Ref: C2PCPX for FCC ID: VN5-CN

Applicant: Ascensia Diabetes Care US Inc.

This letter is to request a C2PCPX change to implement the following proposed updates to the hardware of the device:

Figure 1: Area of PCB Impacted by Change

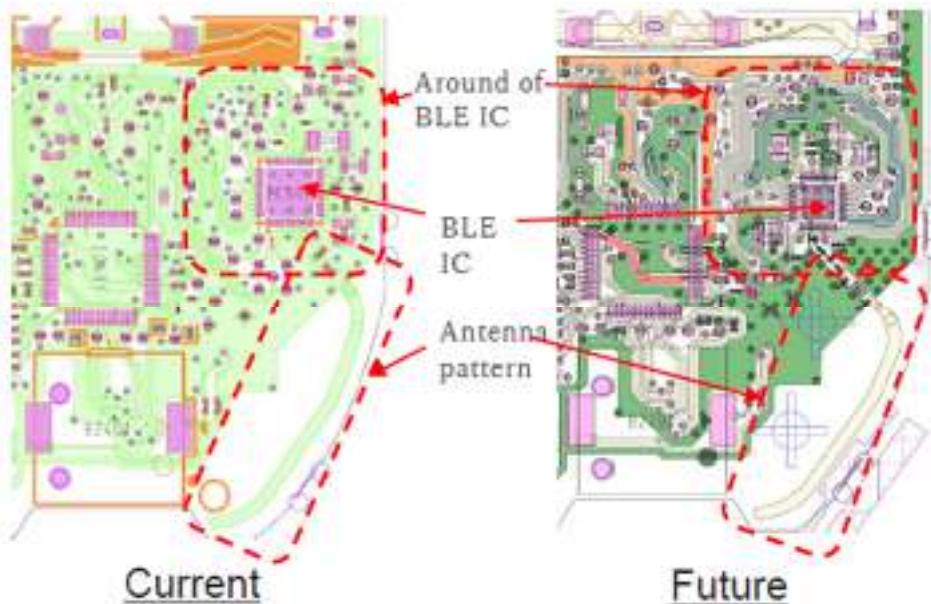
In conjunction with the IC replacement, supporting peripheral components will be updated. This will result in a minor board layout update to accommodate the new BLE IC. The functionality of the RFE block remains unchanged and is not impacted by these modifications.

Figure 2: RFE Block of Toshiba BLE IC (current)

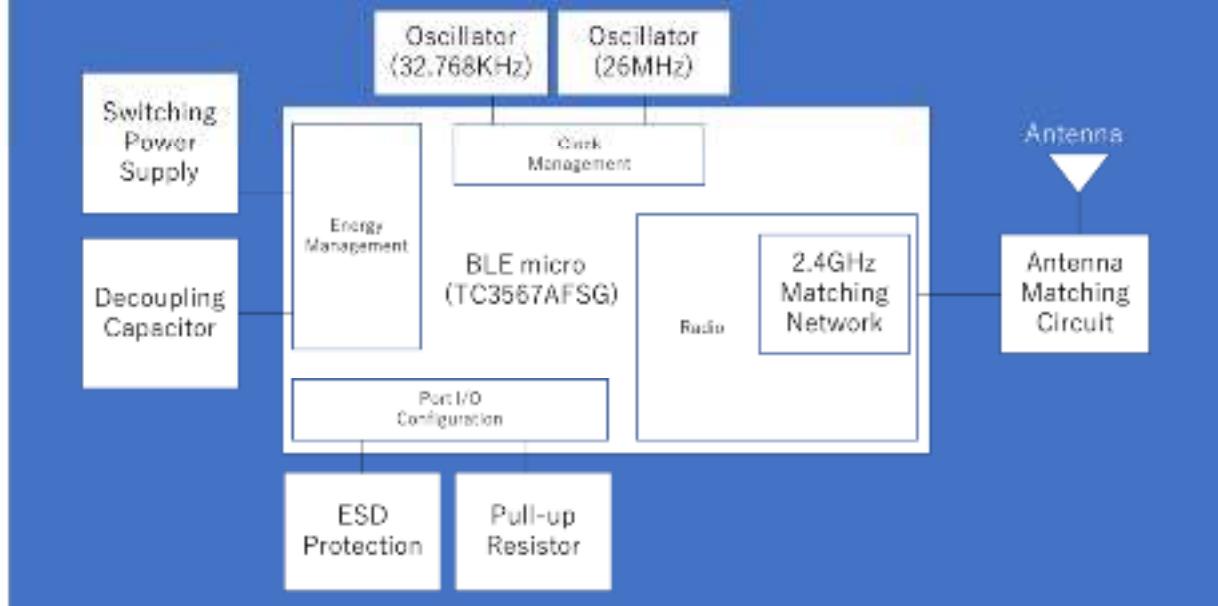
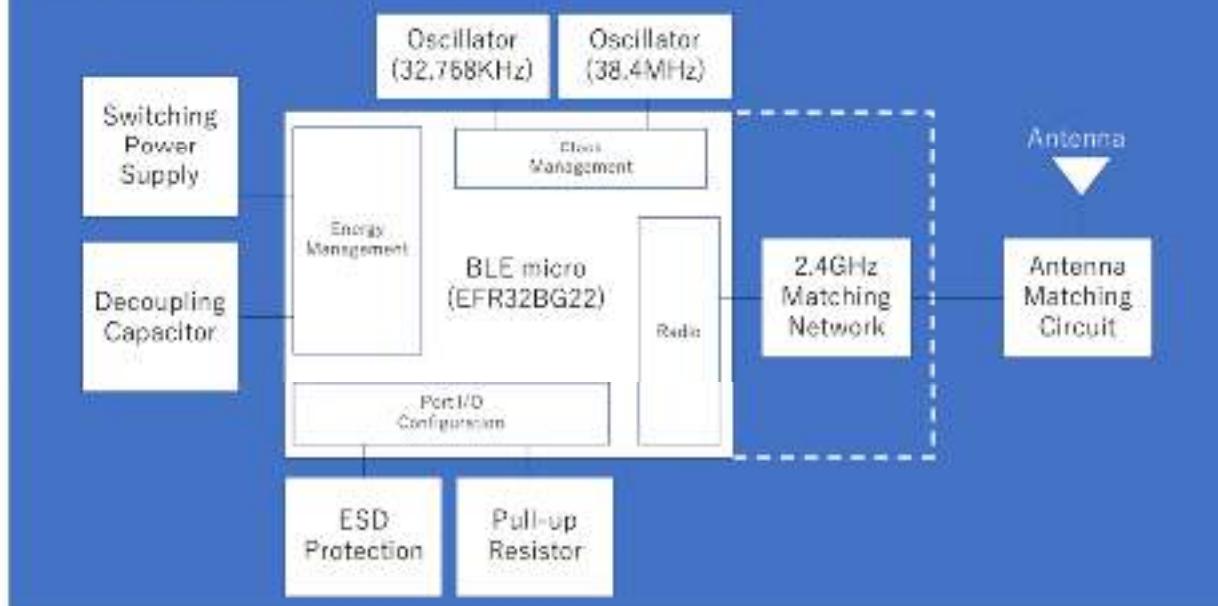
The currently approved Toshiba BLE IC (as part of VN5-CN) is reaching end-of-life and will be replaced by the proposed Silicon Labs BLE IC.

Figure 3: RFE Block of Silicon Labs BLE IC (proposed)
